ADDENDUM TO PLANNING ASSESSMENT REPORT

JOINT REGIONAL PLANNING PANEL (Southern Region)

JRPP No	2012STH001
DA Number	2011.500
Local Government Area	Bega Valley Shire Council
Proposed Development	Designated Development – Extractive Industry (Sand & Topsoil)
Street Address	Nullica Short Cut Road, Boydtown
Applicant/Owner	Bruce Lyon (Boydtown Pastoral Company Pty Ltd)
Number of Submissions	10 (including past submissions)
Recommendation	*
Report by	Mark Fowler Development Control Planner (Bega Valley Shire Council)

Map 1 – Proposed amended Staging of Pit 1

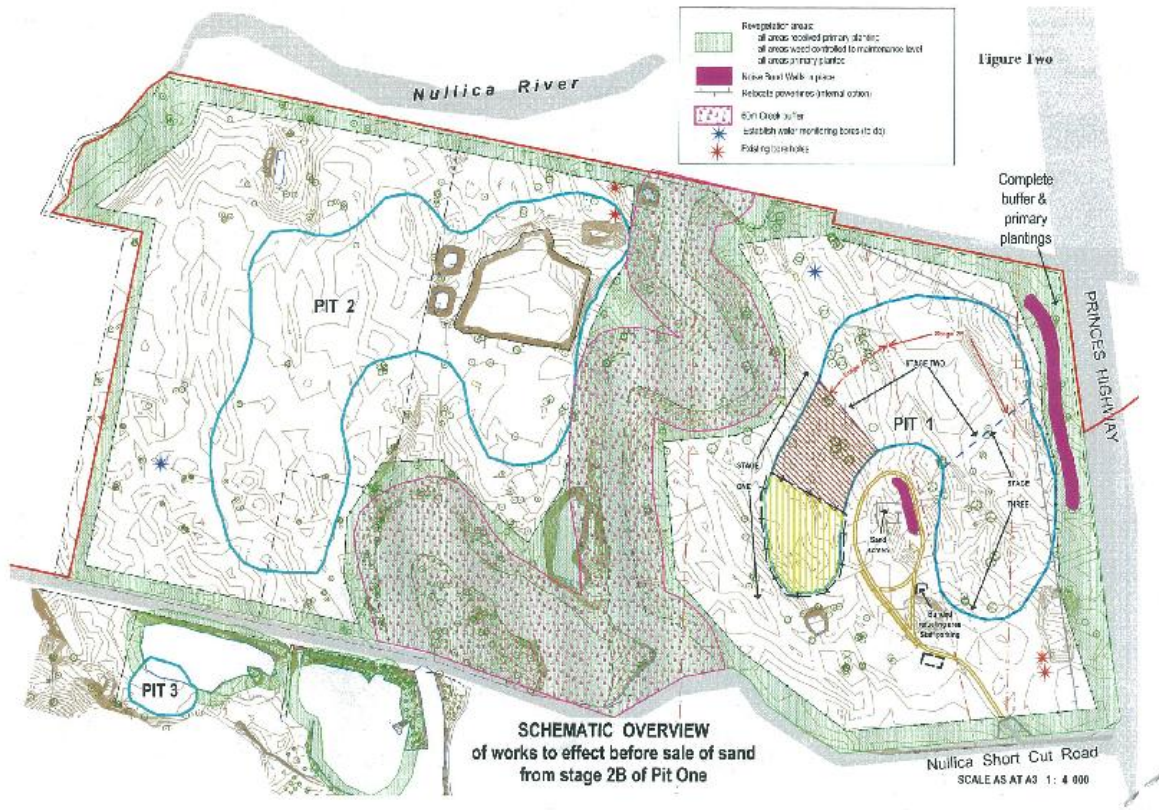
The extent, quantities and operation otherwise described in written and graphical form in the EIS remain unchanged. The applicant has requested that the staging of Pit 1 be amended in accordance with Map 1 detailed on Page 4. The applicant detailed three main reasons for the request being:

- "1. The original Stage 1 and 2 each contain a power line that will require relocation. Recent indications from Essential Energy are that this may take considerably more time than originally envisaged. This would have the potential to delay the commencement of extraction by up to a year longer than otherwise possible.*

- 2. Commencing extraction in the west of Pit 1 will have noise mitigation benefits for the Caravan Park due to increase distance.... This will allow also the beneficial, second bund and for a phased construction of the main entrance of the main eastern bund near the property boundary.*

- 3. The South-west half of what is now proposed to be Stage 1 contains no trees and therefore will not incur the additional process for tree removal required for the protection of fauna which can take 12 months to complete. Commencing in this south-west section generates up to 2 years supply which allows time for both tree removal in accordance with the required fauna protection strategy and for power line relocation."*

The applicant provided an Addendum Noise Assessment report from Wilkinson Murray dated 10 May 2013. To address any potential additional impacts on Twofold Bay Caravan Park occupants as a result in the amendment to the proposed staging of Pit 1, the Addendum report recommended the following;

- Construction of a new 70 metre 4 metre high bund between the centrally located screening plant and the caravan park. A new screening plant is proposed.
- Extraction of sand from Stage 1 area of Pit 1.
- Extract sand from the western side of Stage 2 up to 20 metre from the power line.
- Prior to extraction on the eastern side of the Power line in Stage 2 of Pit 1, finalise construction of a 3 metre high eastern noise bund to be 300 metres long.
- Extract sand from west to east in the remainder of Stage 2.
- Extract sand from Stage 3

Further, during the entire extraction period for Pit 1, the recommended 70 metre long noise bund between the Caravan Park and the sand screen is to be maintained. The report concludes that based on revised excavation methodology and noise control measures being implemented as outlined above, the proposal would meet the established noise criterion of $L_{Aeq}(15 \text{ minutes})$ 41 dBA. The staging of Pit 1 including the inclusion of the addition 70 metre bund wall is detailed below in Map 1.
